P23-15 Tru-Fit Addition

Property Owner: Reagan Land Company LLC
Applicant: Bob Workman
Location: 460 Lake Road
Zoning: I-1 (Industrial)
Request: Site Plan approval for a building addition and parking expansion

Staff recommends **approval** of application P23-15 as submitted.

...TFP 2023 BLDG ADDITION AND SITE WORK
MEDINA, OHIO

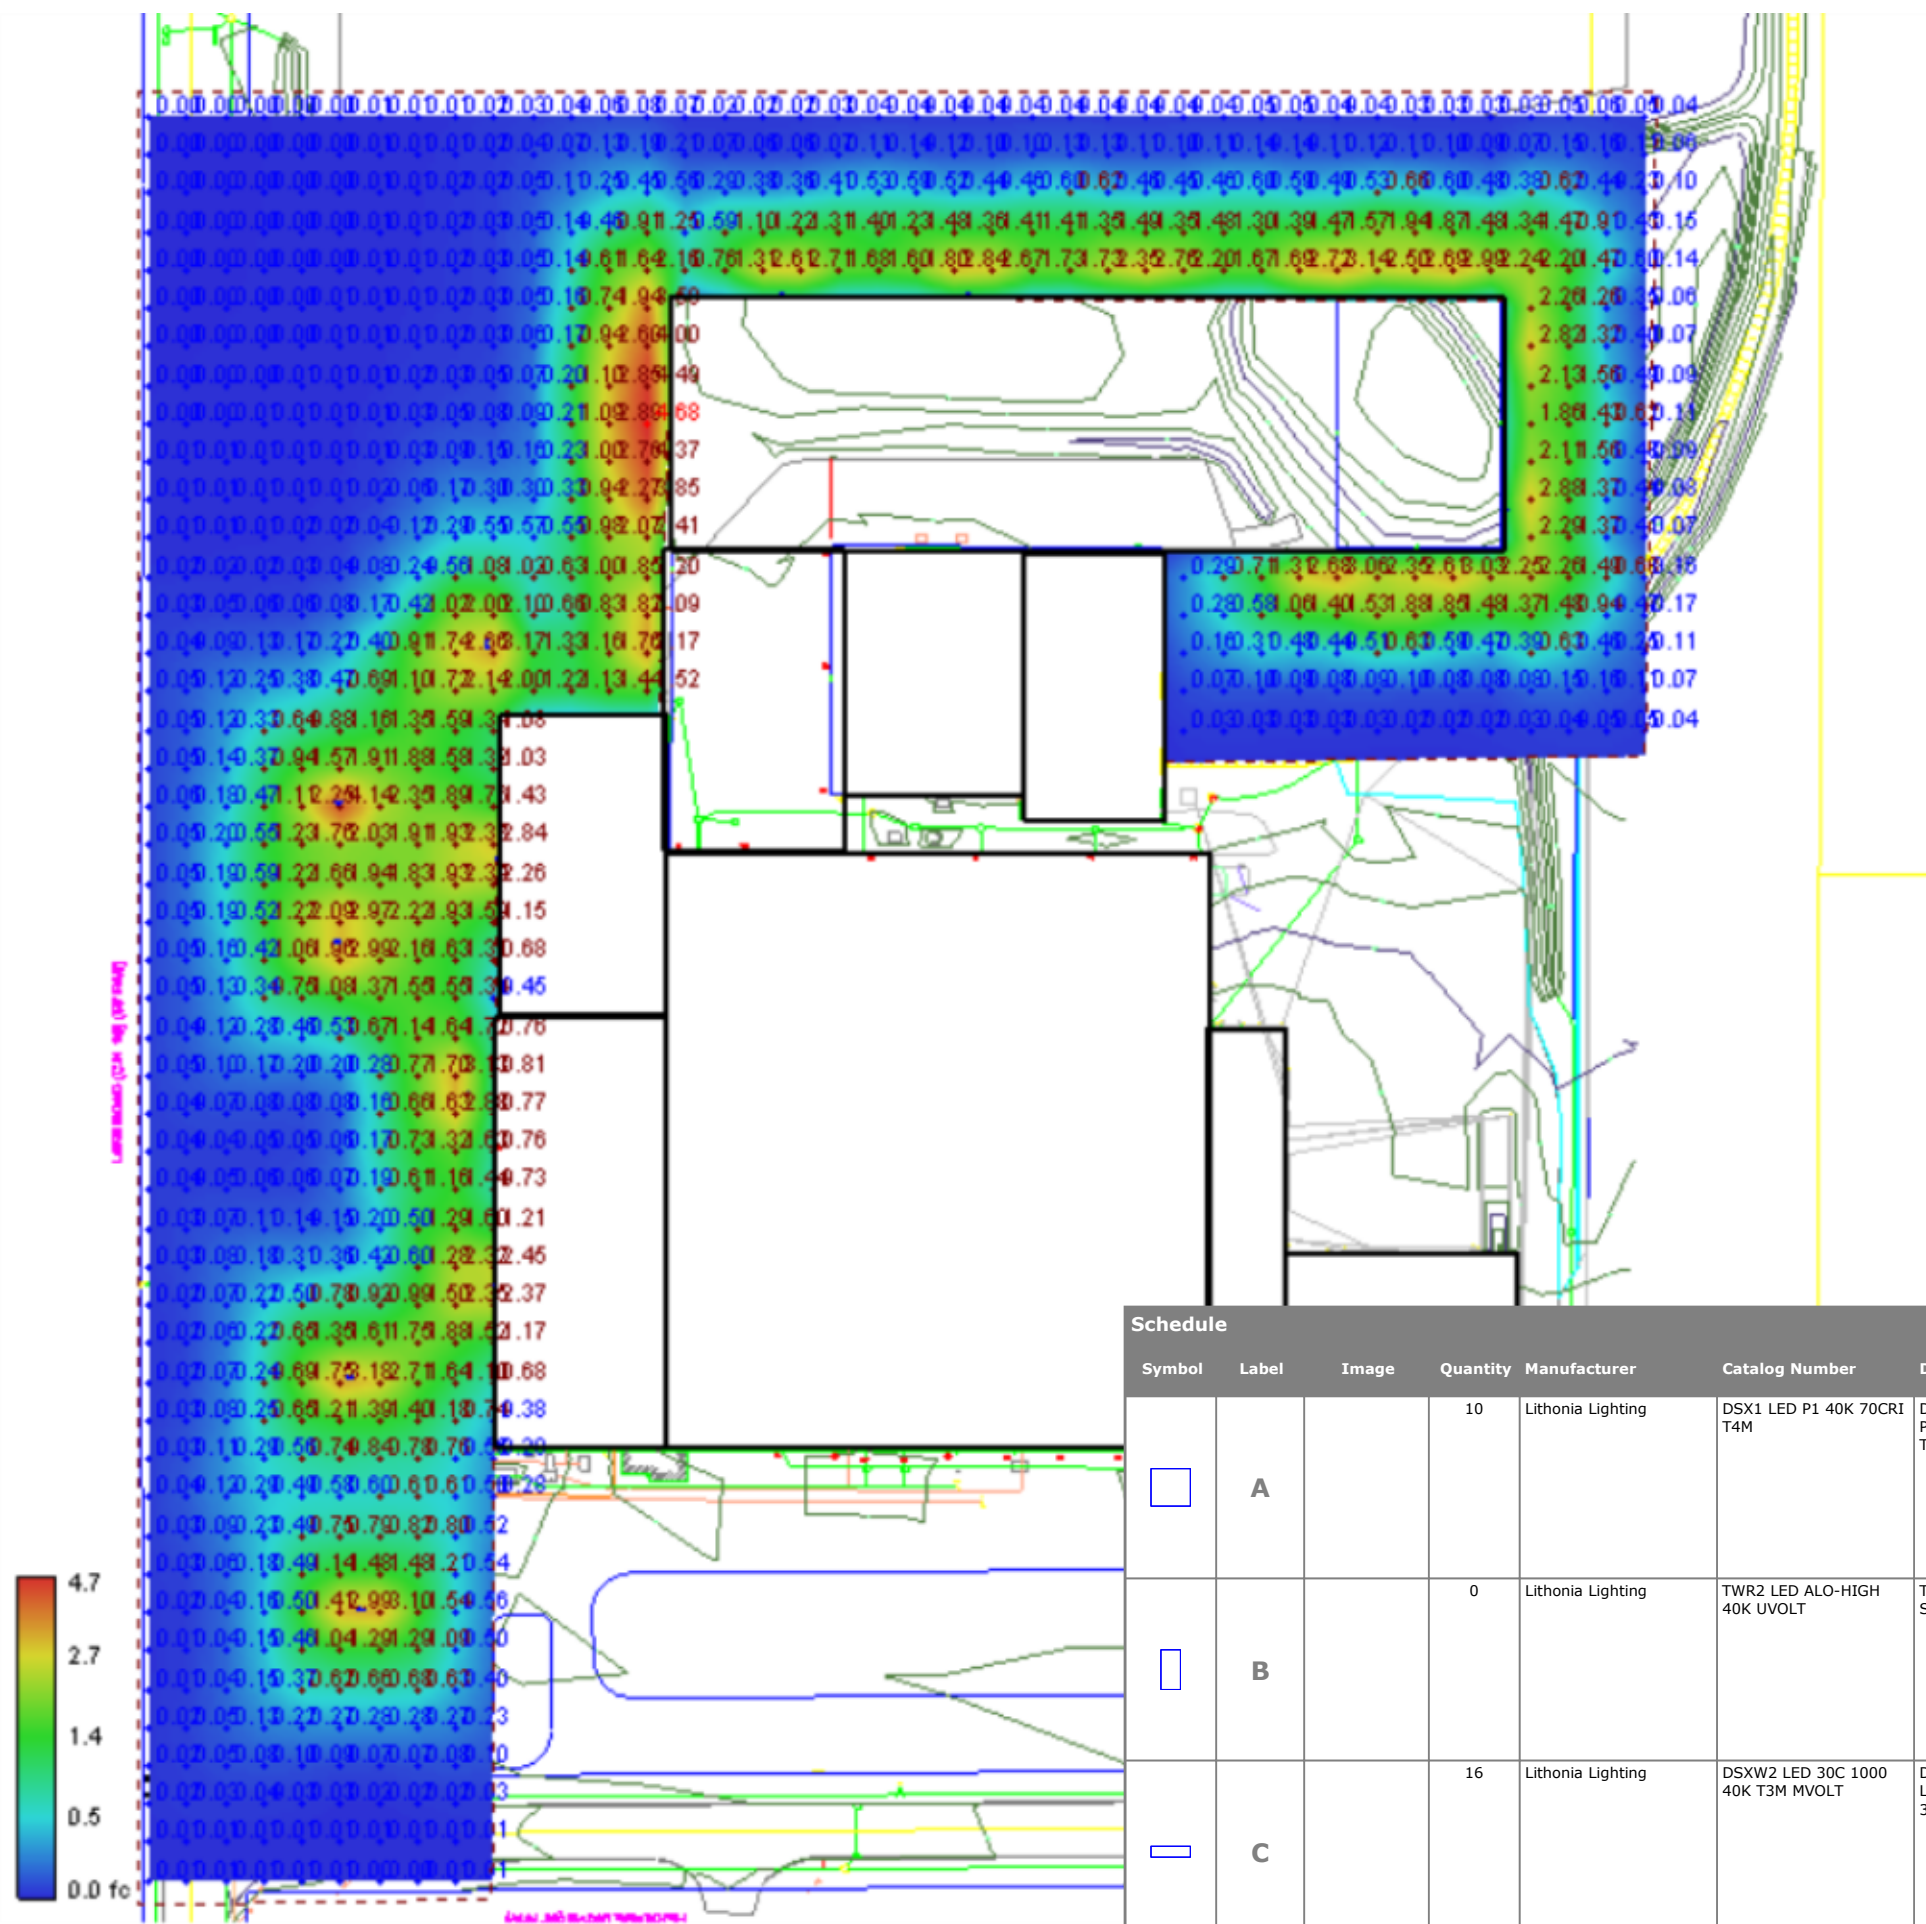
Lighting must comply with Section 1145.09(c) including a photometric plan, full cut-off fixtures, and a maximum lighting height of 25 ft. A lighting plan has been submitted, including a compliant photometric plan, fixtures, and height.

DRAWING TITLE
EXTERIOR ELEVATIONS

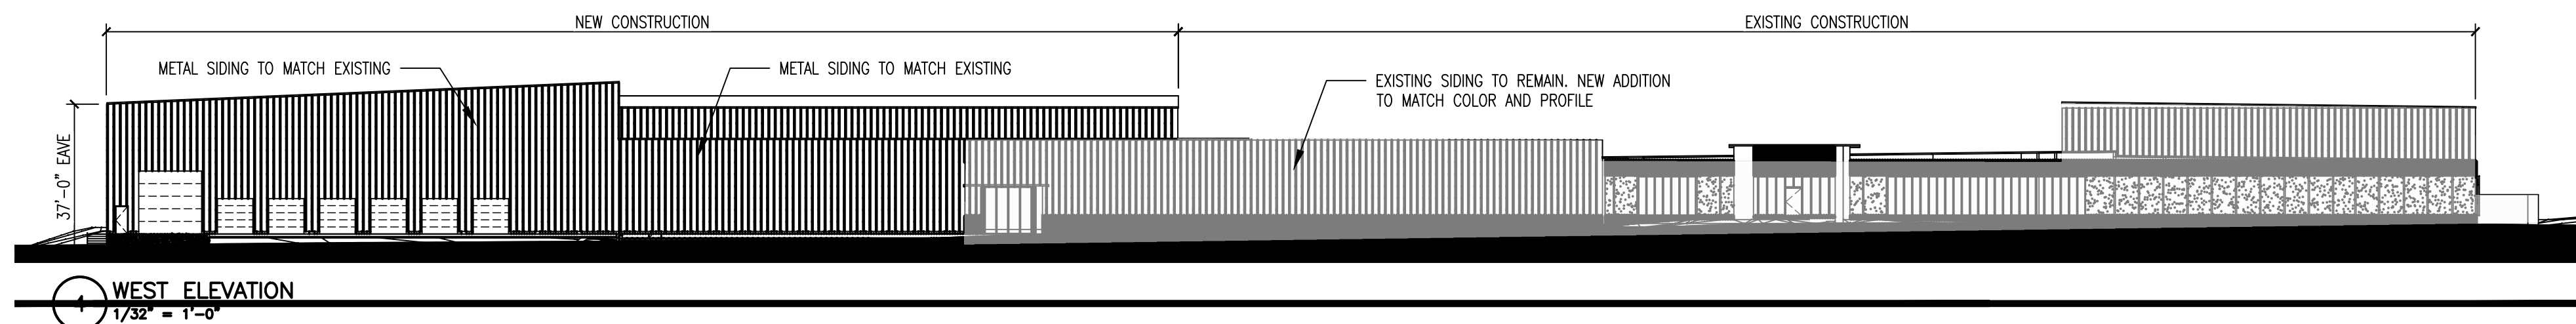
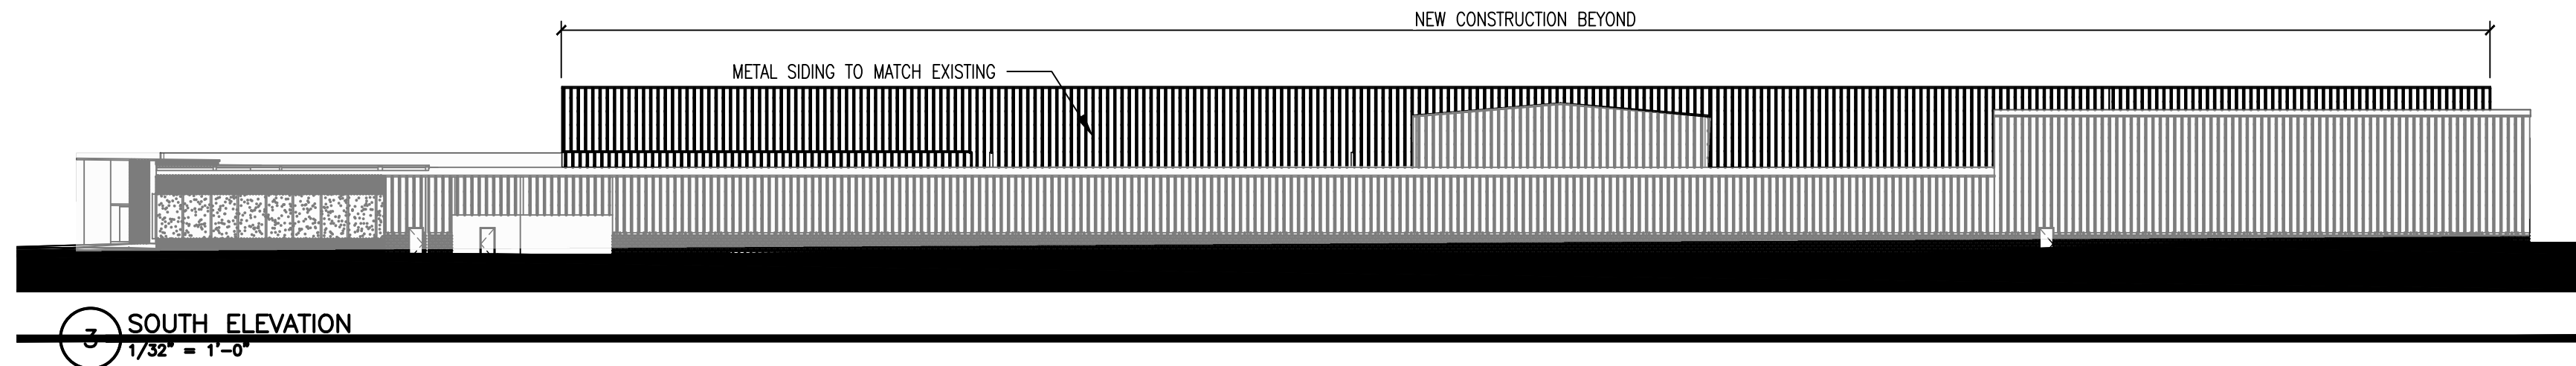
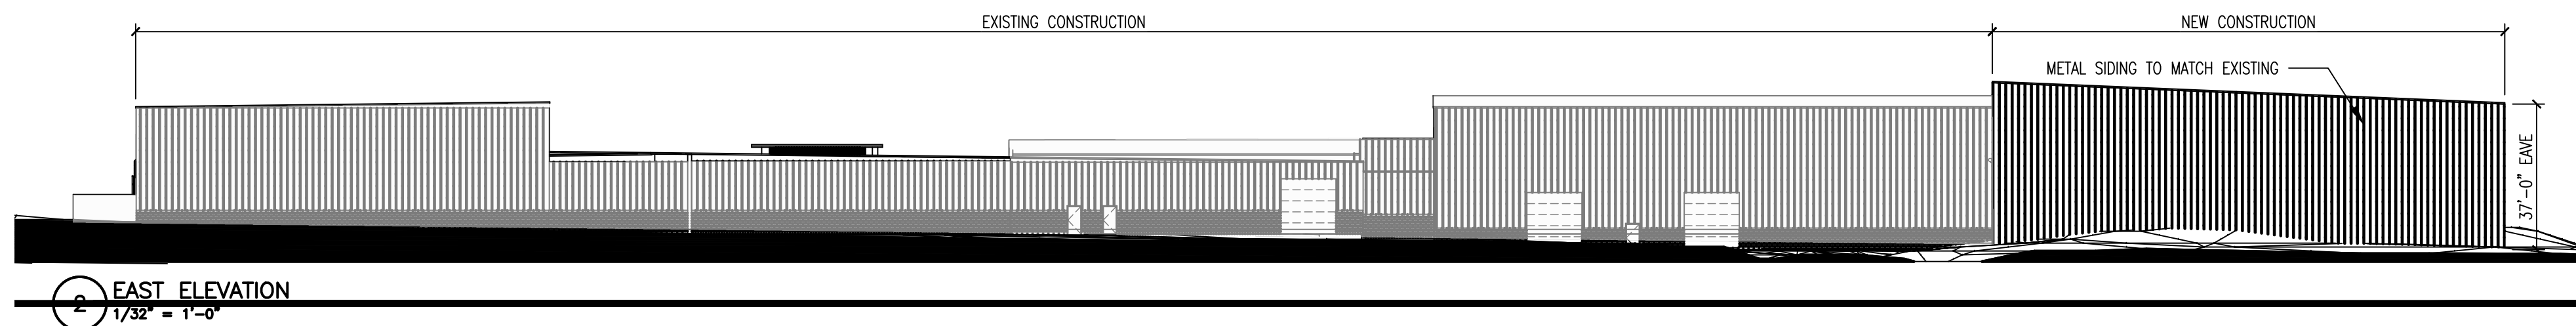
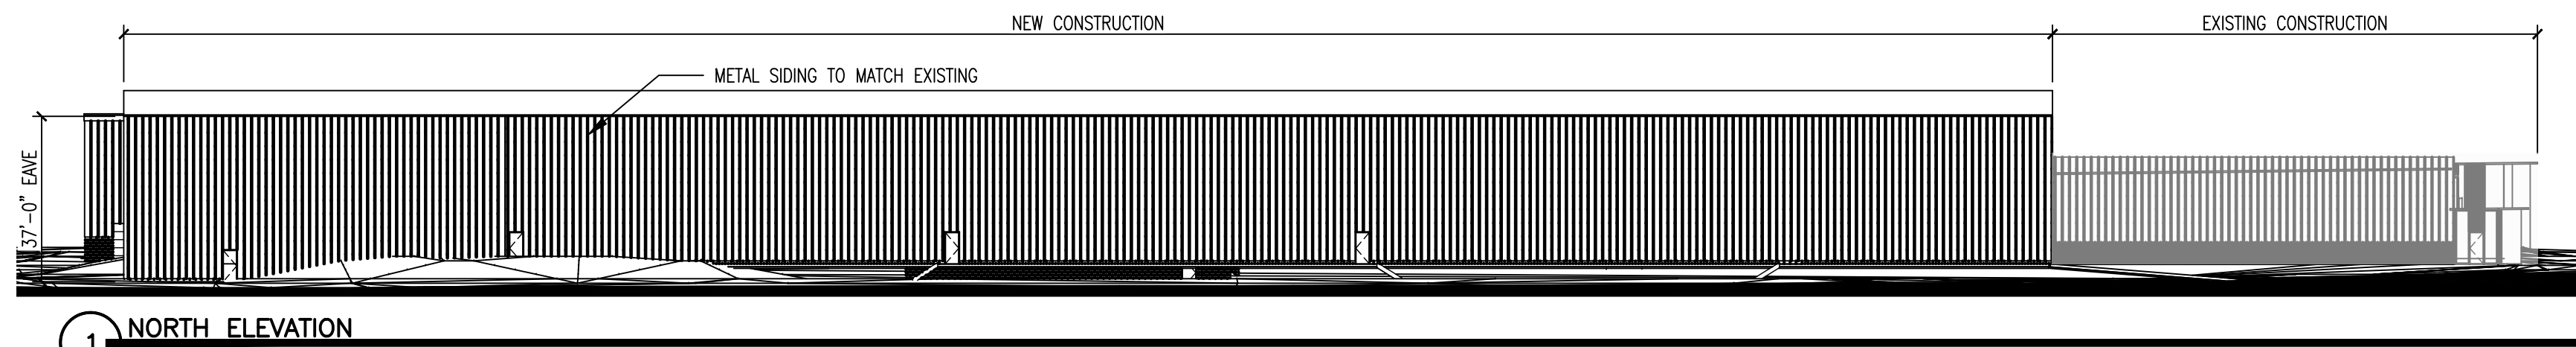
Architectural building elevations indicate a metal-sided addition, which will match the existing building. As noted, overhead doors are incorporated on the west building elevation, facing Lake Road.
